RM 12 / RM 12D Rezoning

Langston Heights

Subject: RE: Langston Heights Addition - revised Concept Plan

RE: Langston Heights Addition
Planning Commission Agenda Items on December 10, 2012

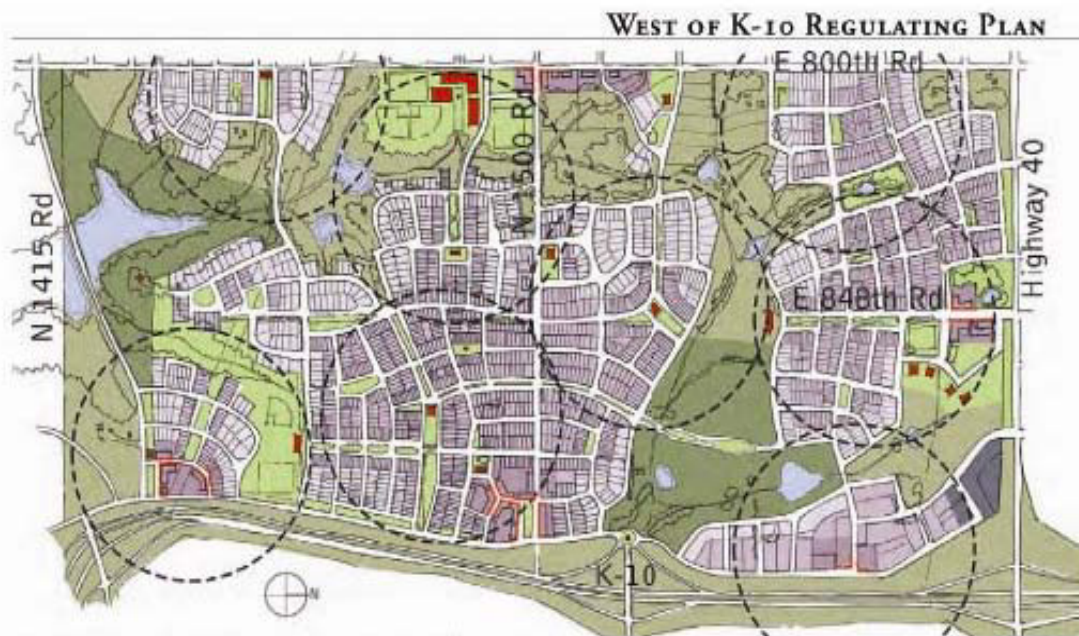
2. The Nodal plan specifically addresses the Diamondhead and Langston Heights area. The nodal plan indicates that "this intersection is envisioned as a multiple-use activity center of low-, medium-, and high-density residential development; commercial, office, research, and industrial activities; public, semi-public, and institutional uses; and parks, recreational, and green/open space opportunities." It further states for the Southeast Corner, that the corner provides an opportunity for a variety of residential, commercial, and office activities. This nodal plan "also designates the majority of its residential uses appropriate for low-

density, single-family neighborhoods with a **small** portion considered appropriate for medium-density residential development. This medium-density development serves as primary buffer between single-family neighborhoods and commercial activities.” It further states that “This nodal plan anticipates more low-density, single-family residential development in the areas surrounding this corner and therefore much of this corner was designated appropriate for similar development to maintain compatibility of surrounding land uses.” The staff report quotes specific sections but fails to address the statement “appropriate for low-density, single-family neighborhoods.” It only constantly quotes “a mixture of housing types... should be encouraged.” We do not dispute the need for a mixture of housing types, but the question is whether this proposal is the correct mixture or the correct location? The developer and applicant admitted at the neighborhood meeting that this type and mix of development “has not been tried or developed in Lawrence.” Why is this established successful neighborhood the place to try this experiment?

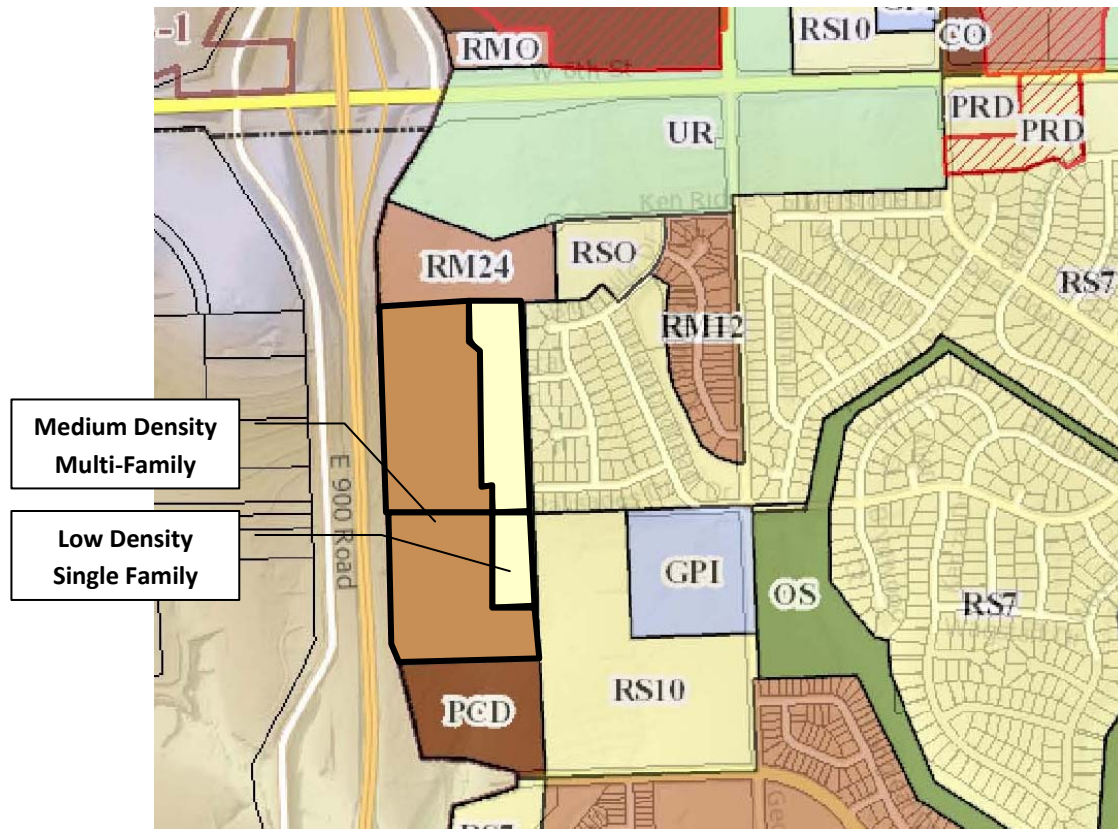
5. The applicant states in the application that the approval of this zoning will “set a developmental precedent for adjacent vacant parcels.” The adjacent parcels indicated refer to the land to the south of the proposed development. Since the applicant specifically references this parcel and indicates that this will set a precedent, then the West of K10 Plan should be used as a guiding document as it addresses this parcel of land. This plan, adopted in 2009, is one of the latest planning documents and combines many of the current planning guidelines. Again, this document indicates the land south of the proposed development to be low-density development.

As the applicant has indicated, the proposed development will be setting a precedent for future land uses. Should this be the case, then a majority of the land uses to the south will be predetermined to be multi-family, medium density land uses (see map below). This is supported by the proposed location of the Renaissance Drive as the applicant would more than likely propose multi-family between the road and K10. The proposed location and its connection point to Bob Billings will encourage medium density development. The map below begins to indicate the pre-determined extent of the southern land and, the quantity of medium density zoning, and is counter to the current adopted land use documents for this area.

Figure E - Pre-determined zoning plan

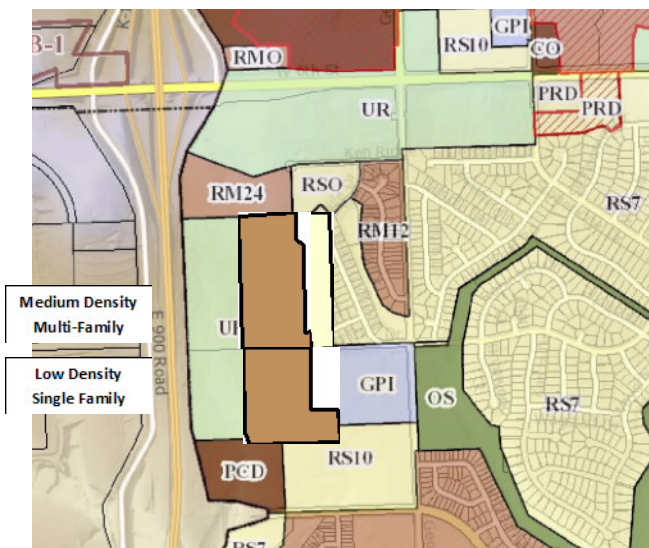
The map at left indicates the pre-determined extent of the southern land and, the quantity of medium density zoning, is counter to the current adopted land use documents.

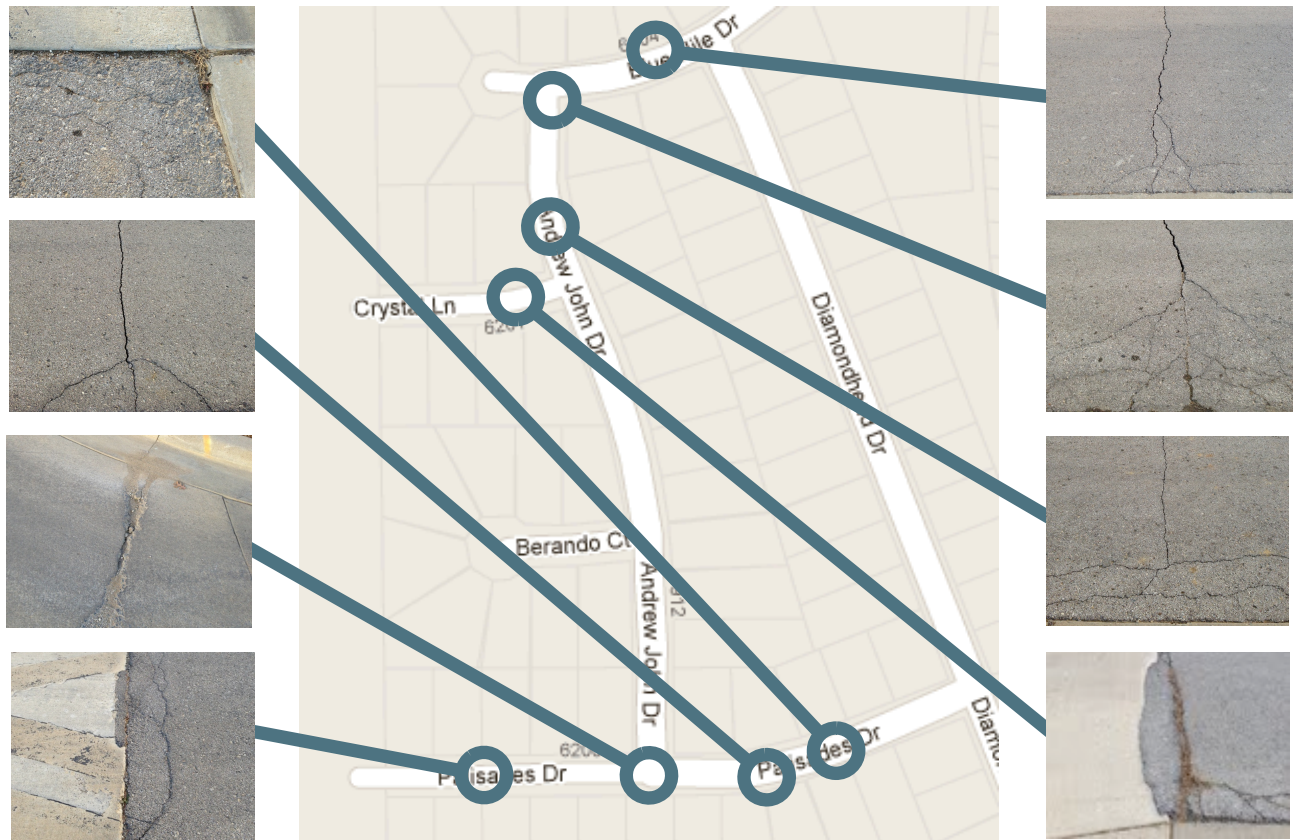
None of the intersections in the community feature traffic signage. The applicants count at least 138 additional trips per hour with the traffic study, but fail to demonstrate its effect within the existing layout. We have already discussed the potential for pedestrian accidents, but the limited sight-lines and lack of any stop or yield signs is an invitation to traffic accidents.
